# City of Alexandria, Virginia

## MEMORANDUM

**SUBJECT:** 4<sup>th</sup> CONCEPT REVIEW OF 500 & 501 NORTH UNION STREET  
(FORMERLY ROBINSON TERMINAL NORTH)  
BAR CASE # 2014-0119

A1

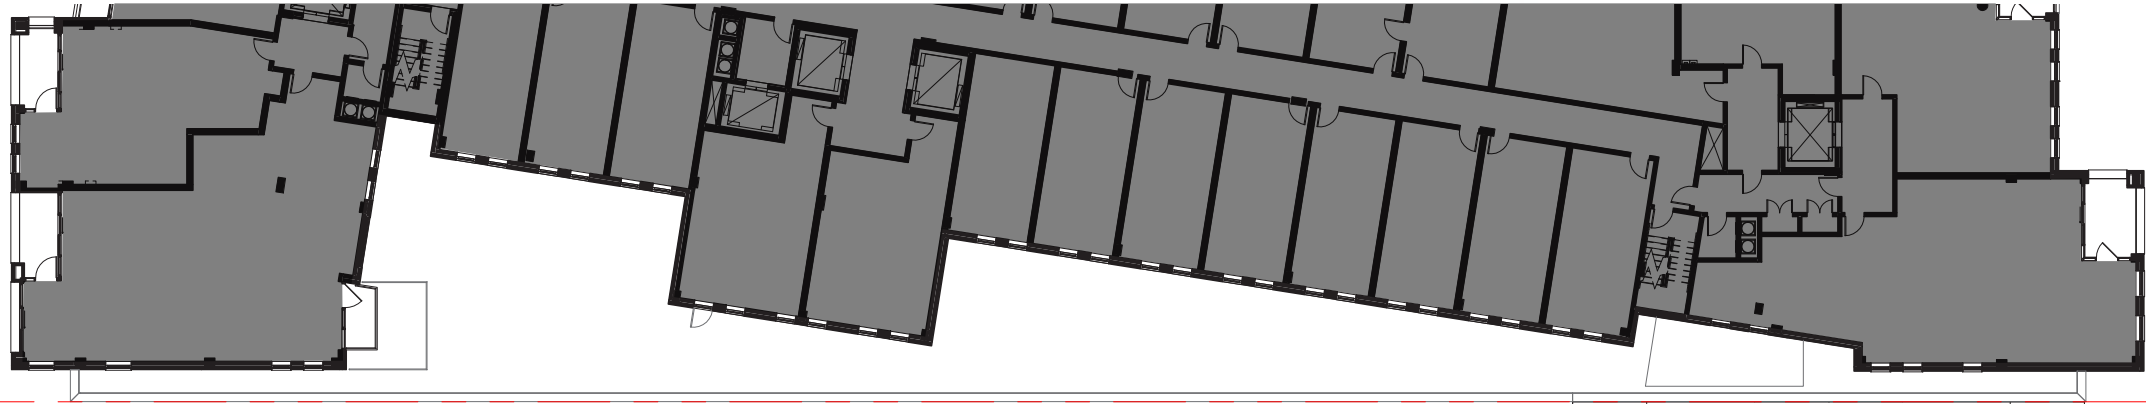
south. The west side will never be viewed the way it is represented in the direct elevation drawing, and the dashed lines on Sheet A1 show that the majority of this elevation will be screened from the west by existing adjacent structures.

A2

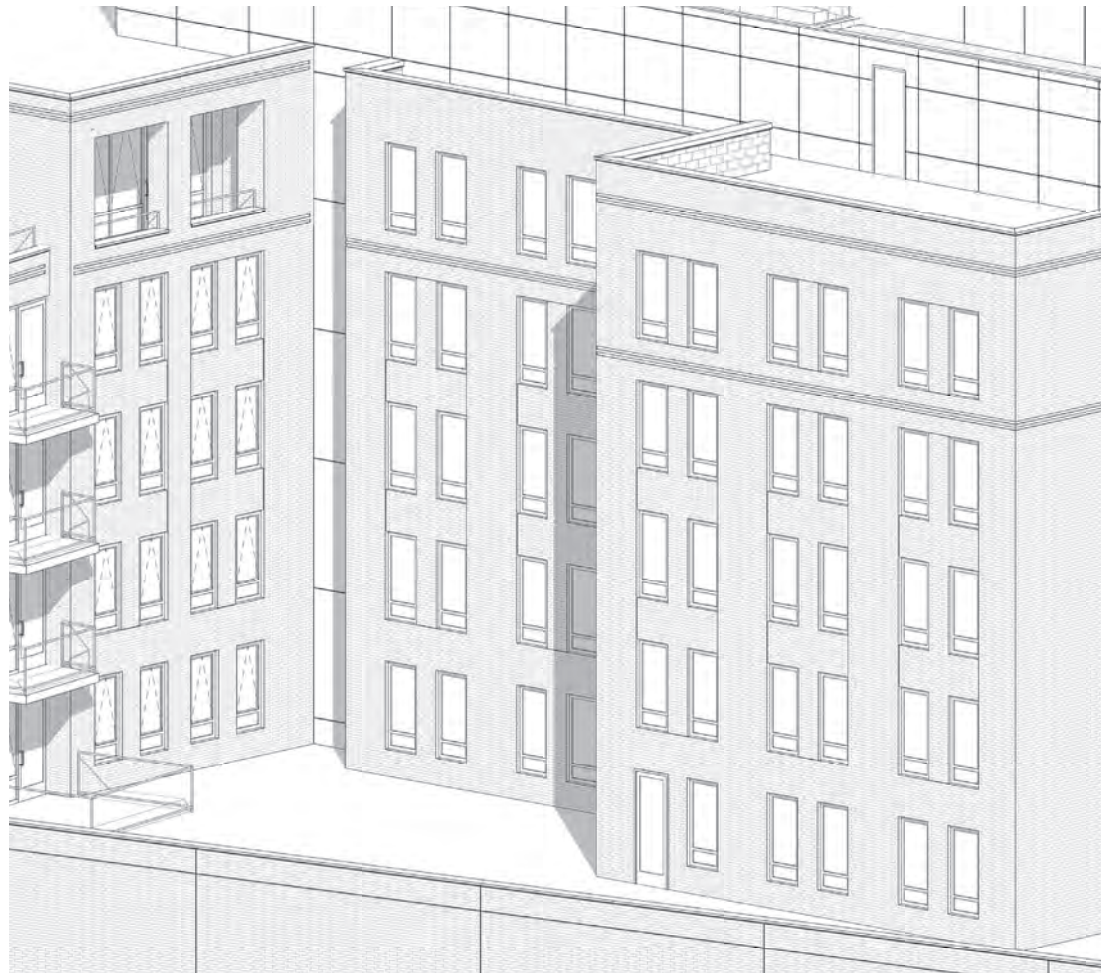
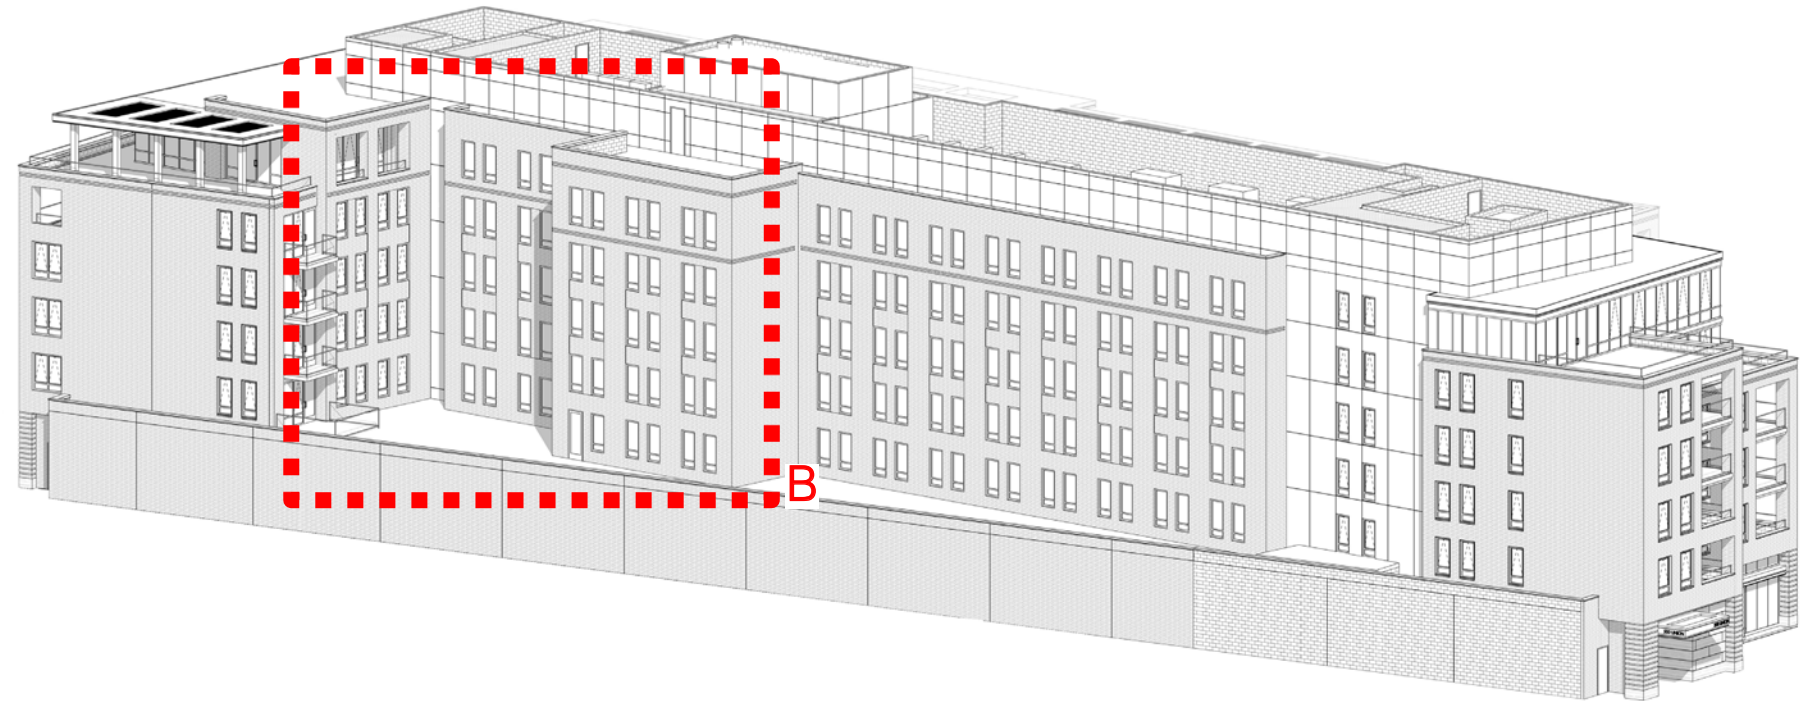
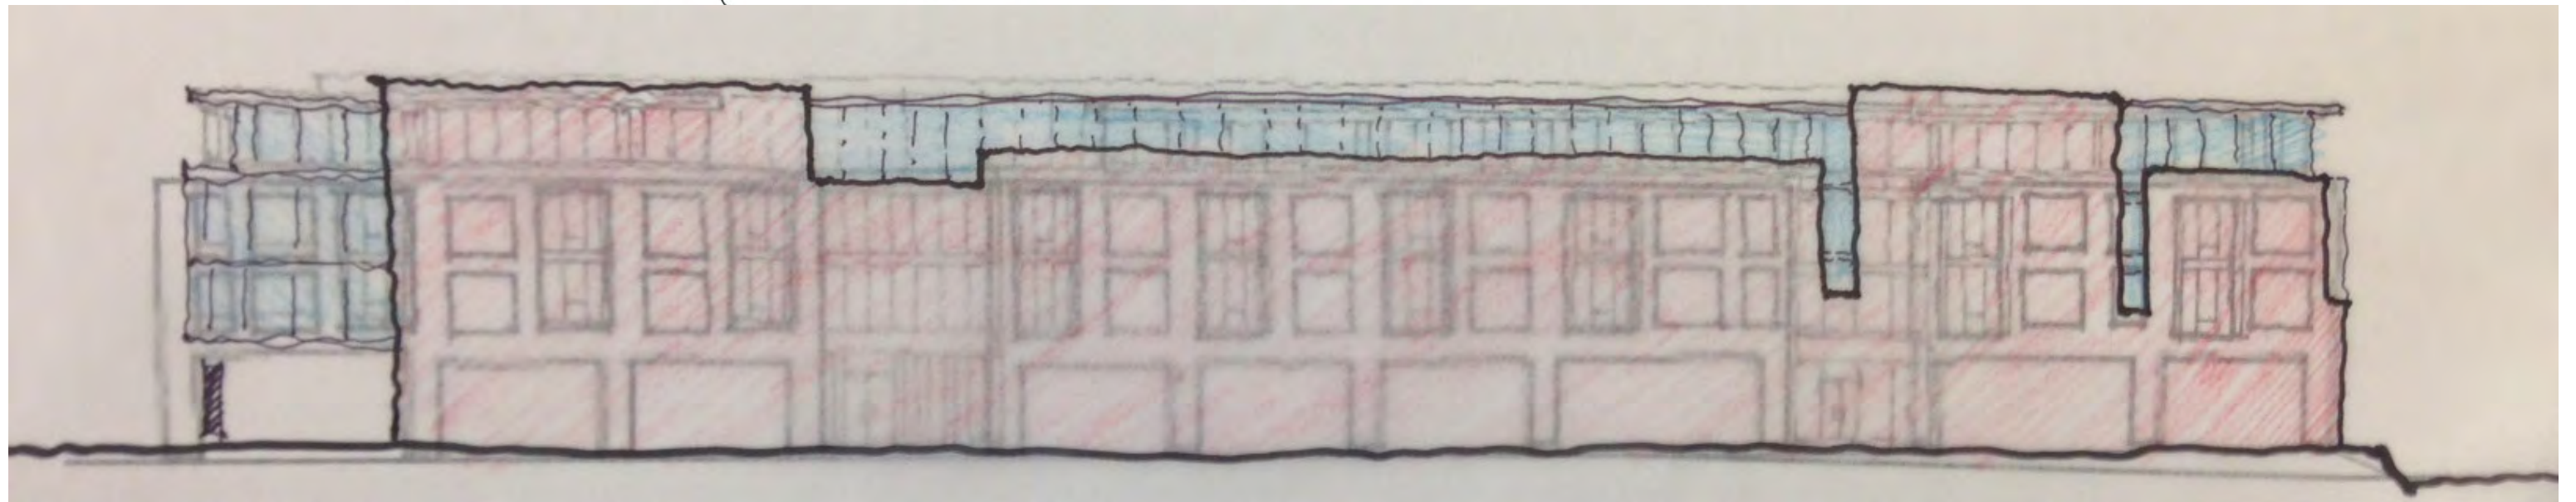
Based on the discussion at the last work session, the applicant has made a few refinements to the rear (west) elevation of the west building. These include variation in the brick color and depth to emphasize paired windows, belt courses that align with adjacent cornices, and additional windows. These organize and give scale to the large wall by providing a base, middle and top, and enliven the rear elevation of the building. The applicant has also provided much better renderings of the west elevation that explain the substantial modeling of the wall and the depth of the wall offsets (Sheet A2) which are sculpturally rich, viewed in perspective from the north and

PROCESS SOUTHWEST PERSPECTIVE

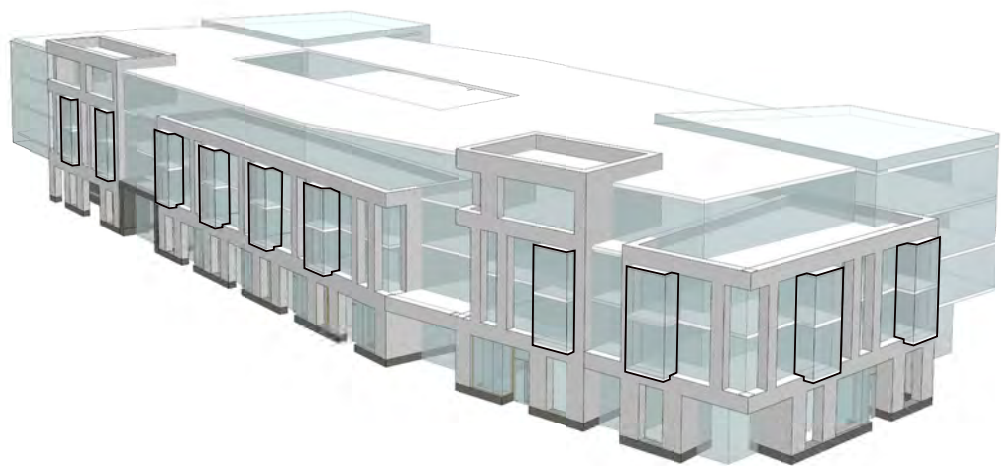
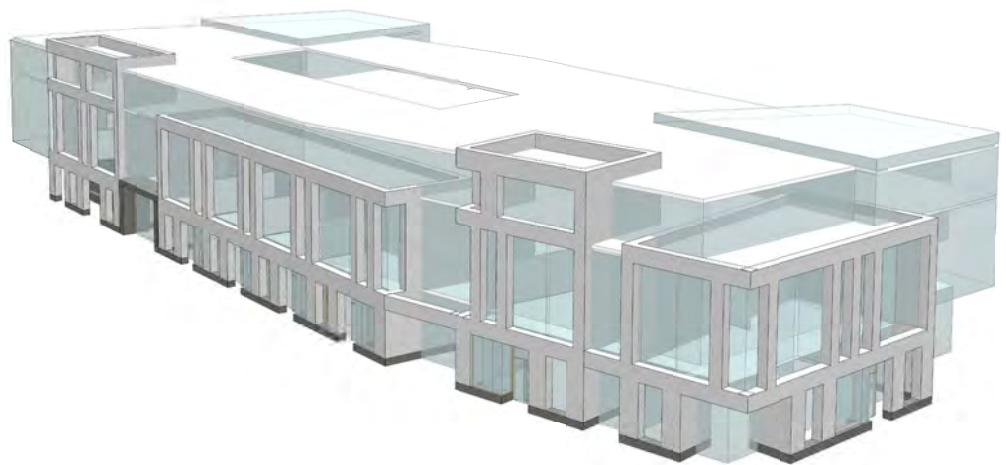
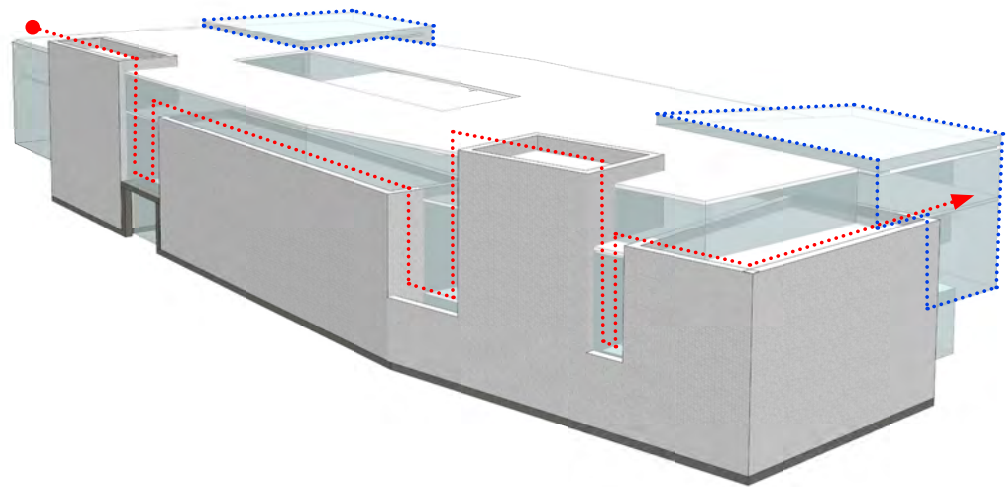
**Figure 1:** In this interim design study, red arrows show the load path of the upper stories bearing on a masonry beam - something atypical of traditional building techniques in historic masonry architecture. At the same time, the heavy piers on the first floor precluded views into the retail spaces fronting N. Union Street (process study on current submission Sheet A4).

A5

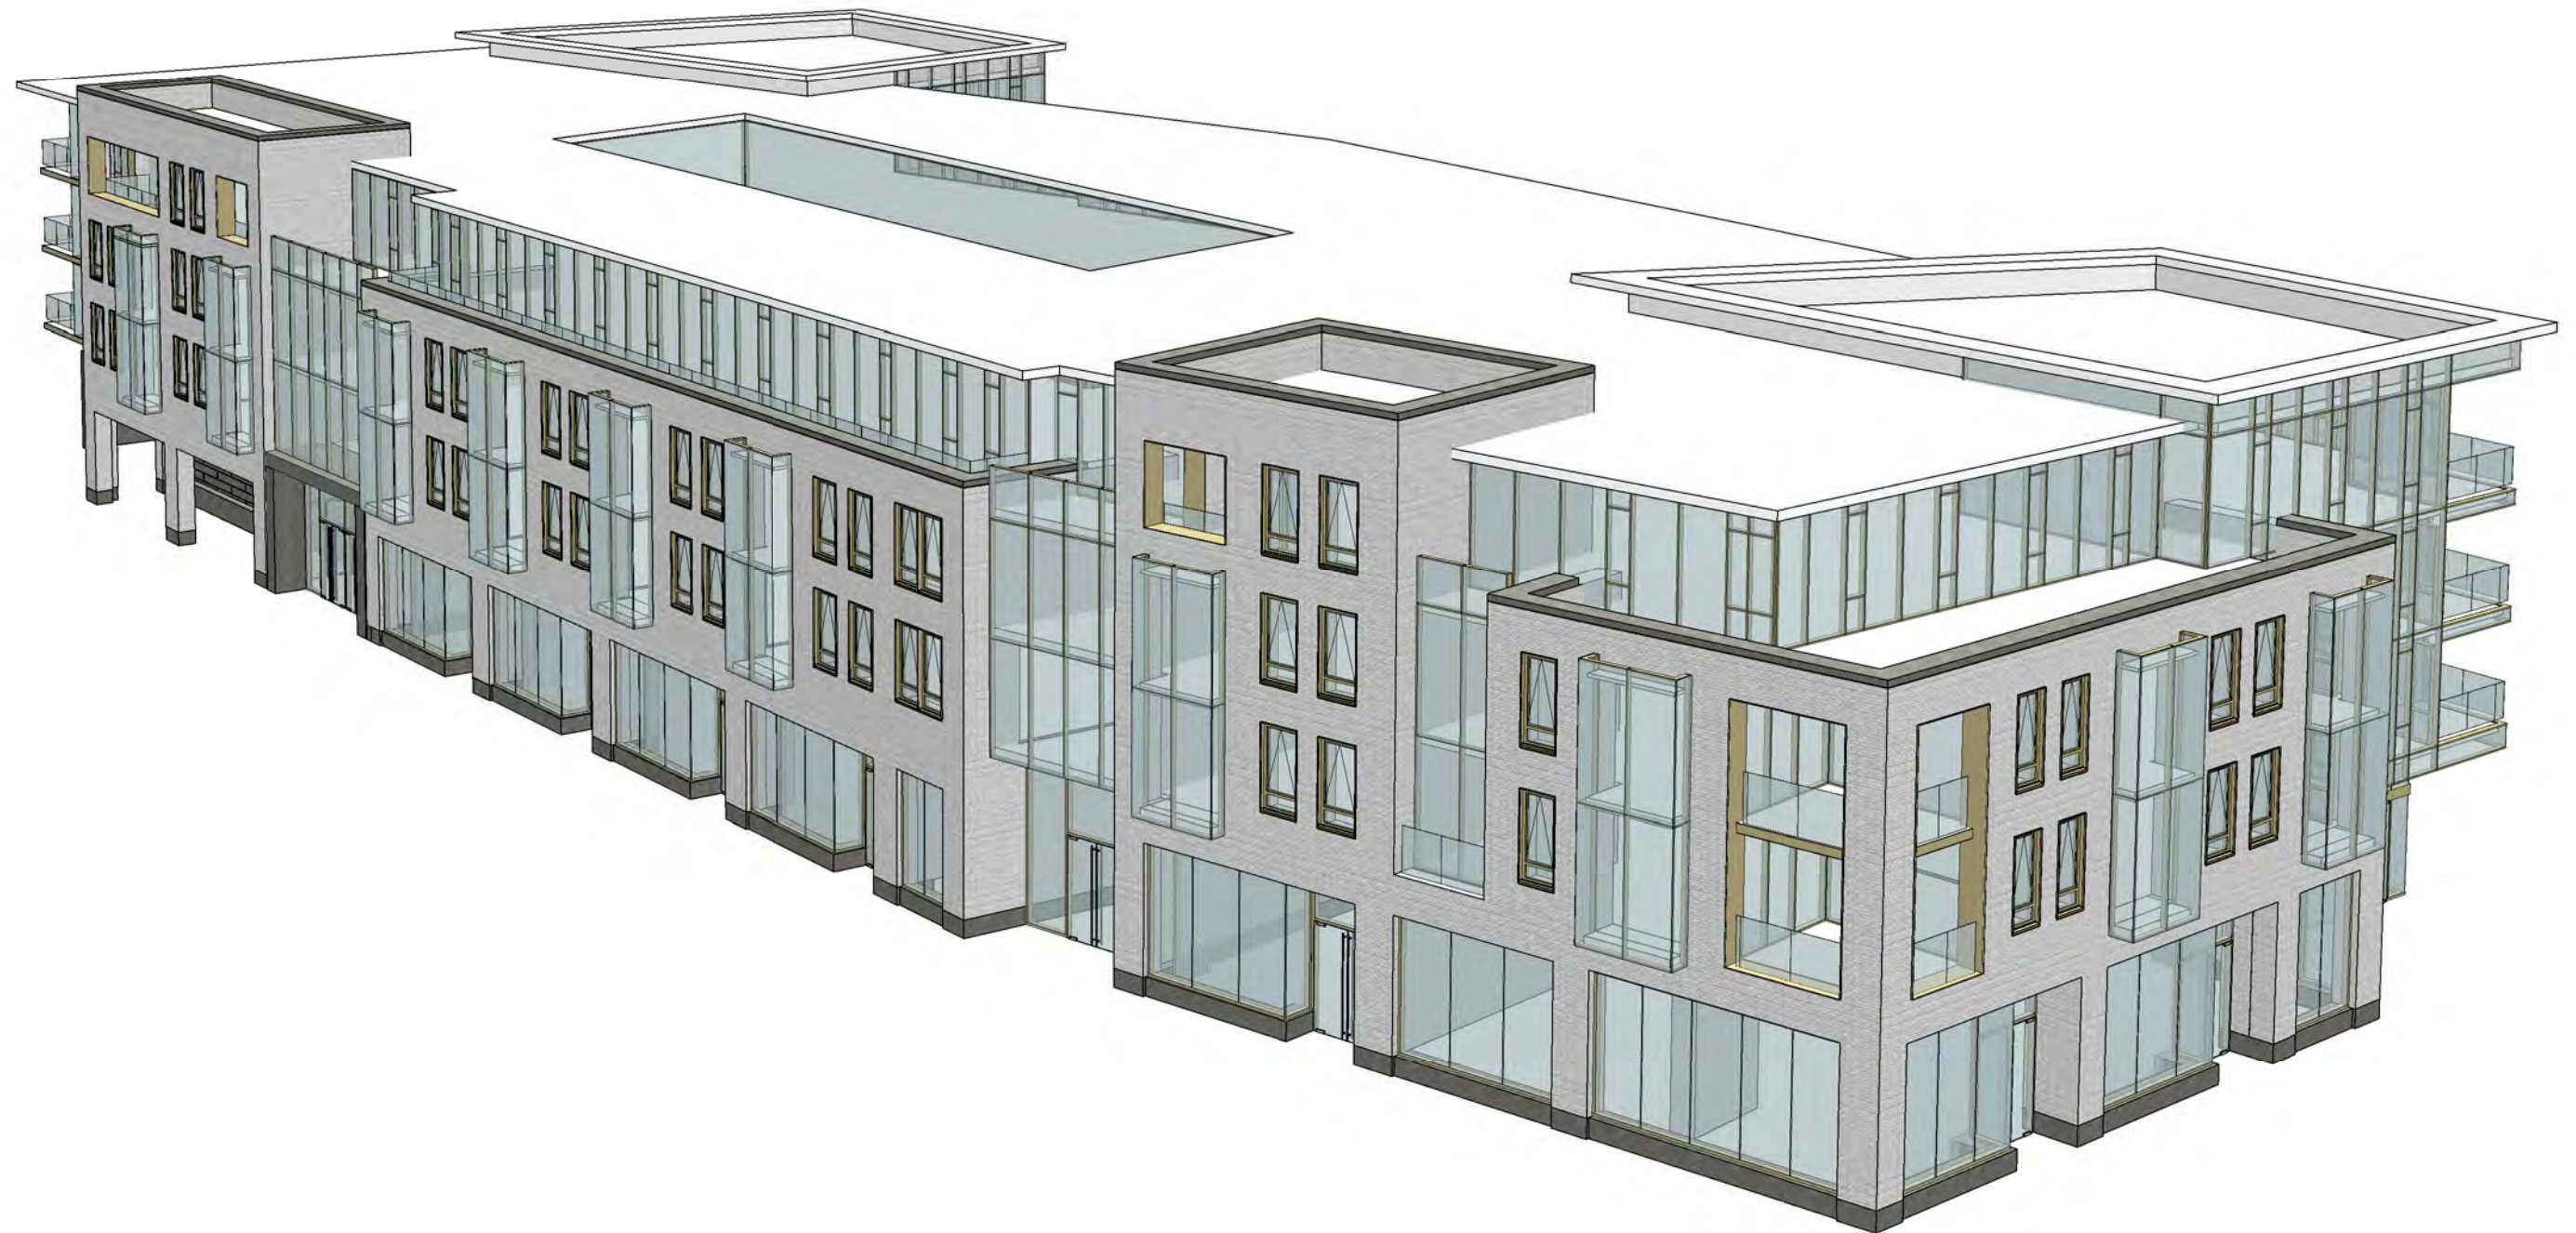
**Figure 2:** Red arrows in the present proposal show the load path traveling directly to the ground, a character-defining feature of Alexandria's historic masonry architecture, with large storefront windows below each bay providing a visually interesting streetscape for pedestrians and establishing a building bay width that relates to the scale of nearby townhouses (current submission Sheet A6).
